## Agenda Item # 4 - HOLDOVER

### MOD-003524-2025

**Proposal:**

APPLICATION NUMBER	4	DATE	December 18, 2025	
APPLICANT	Chris Lieb, Lieb Engineering Company, LLC			
REQUEST	PUD Modification

## SITE PLAN

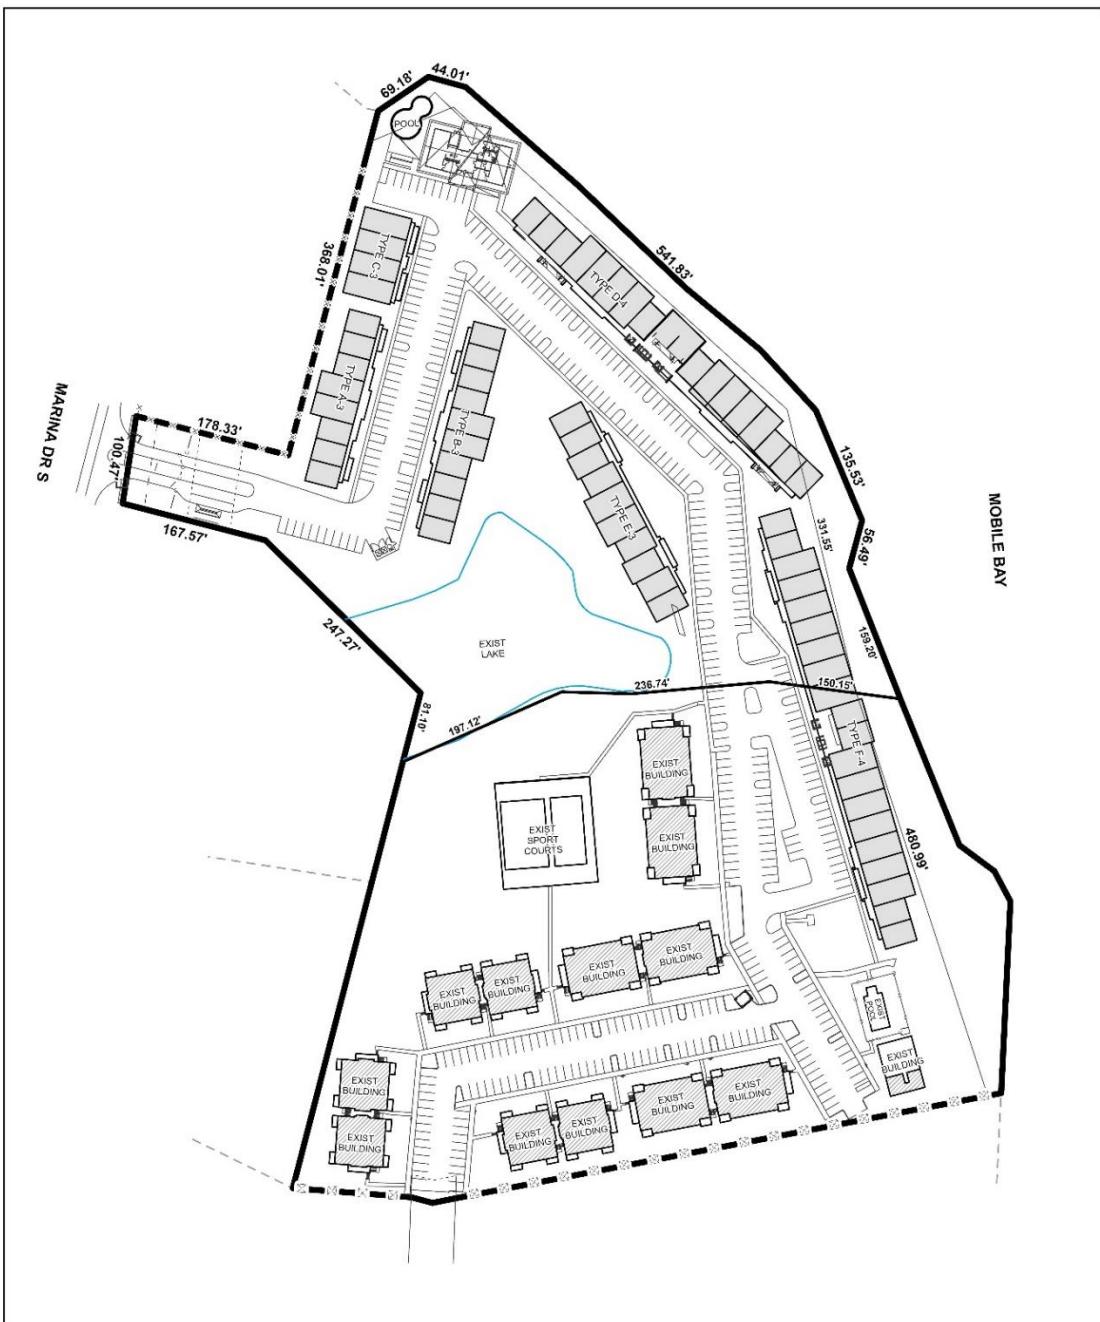
The subject site was heldover at the Planning Commission's October 16, 2025, meeting to allow the applicant time to address concerns related to the proposed development's design. The applicant has since submitted a revised site plan to address staff's concerns.

The site plan has been revised to state that the site has 96 existing units, and 178 units are proposed, for a total of 274 dwelling units. It should be noted that based on the overall size of the property, up to 408 dwelling units could be allowed on the site. With 274 dwelling units proposed, the site is required to have 411 parking spaces. The site plan indicates that a total of 412 parking spaces will be provided. It should be noted that the existing parking lot has several areas where there are more than 12 contiguous parking spaces. If approved, the site plan should be revised to depict the provision of a landscaped island to break up these areas.

The applicant has revised the proposed site plan to depict the required sidewalk along Marina Drive. However, there is no pedestrian connection from the public sidewalk to the structures on the site. Furthermore, if approved, the sidewalks in front of each of the buildings should be revised to connect with each other.

The site plan has been revised to depict a 6-foot (6') tall wooden privacy fence where the site abuts residentially developed property. This should be retained on the site plan, if approved.

The site plan has been revised to include the building footprints of all existing and proposed structures, clearly depicting that the building footprint will be increased by more than 50%, thus requiring the site to fully comply with tree planting and landscape area requirements. Notes were added to the site plan stating that the site will provide compliant bicycle parking spaces, parking lot lighting, building design, and tree planting and landscape area requirements, which should be retained on the site plan, if approved.

The proposed site plan depicts new dumpsters being located on the site. If approved, a note should be placed on the site plan stating any dumpster placed on the property will comply with the placement and enclosure standards of Article 3, Section 64-3-13.A.4. of the UDC.

Additionally, the applicant states that the proposed new structures will exceed the maximum allowable height of 50-feet, but will not exceed 65-feet in height. While the applicant does not specifically provide the reason for this, it is most likely due to the site's proximity to water, and therefore structures must be elevated to comply with floodplain management requirements. As such, the proposed increased building height is a function of the land, and not the use, and can be considered as part of the current Major Modification application.

Finally, the site plan has been revised to include the correct development name as well as the legal descriptions for the entire development.

1. Revise the NAME and other information shown in the TITLE BLOCK that is wrong (i.e. LEIGHTON VILLAGE, TWILLEY BUILDERS, LLC.)
2. Retain NOTES #1 - #8, as shown on the Grandview Pointe Apartments PUD PLAN sheet 1 of 1 dated 3/29/2023.

The site plan depicts the existing and proposed structures on the site, but does not provide the number of units that are existing on the site currently, nor the total number of units proposed after the addition, making it difficult for staff to determine if there will be sufficient parking available on the site. The applicant should revise the site plan to provide both the number of existing and proposed units, as well as the number of parking spaces available.

A dumpster is shown on the site plan with an enclosure on unknown materials and design. If approved, a note referencing compliance with dumpster enclosure and placement standards of Section 64-3-13.A.4. of the UDC should be added to the Final PUD Site Plan.

The application submitted does not include a legal description for the entire site, and will need to be revised, as the PUD pertains to both Lot 1 and Lot 2 of the Grandview Apartments Subdivision. Furthermore, the site plan states that it is for the “Leighton Village”, which is owned by “Twilley Builders, LLC”. As this appears to be information from an unrelated project, the site plan should be corrected.

1. Provision of the lot size in square feet and acres on the Final PUD Site Plan;
2. Retention of the sidewalk along Marina Drive South;
3. Revision of the site plan to provide a pedestrian connection from the public sidewalk to the structures on the site to comply with Article 3, Section 64-3-3 of the UDC;

4. Revision of the site plan to connect sidewalks in front of all buildings on the site;
5. Revision of the site plan to break up areas of more than twelve (12) contiguous parking spaces with a landscape island;

10. Provision of a note on the Final PUD Site Plan stating the maximum allowable building height is 65-feet;
11. Retention of the note on the Final PUD Site Plan stating that the site will comply with tree planting and landscape area requirements of Article 3, Section 64-3-7 of the UDC;

13. Provision of a note on the Final PUD Site Plan stating any dumpster placed on the property will comply with the placement and enclosure standards of Article 3, Section 64-3-13.A.4. of the UDC;
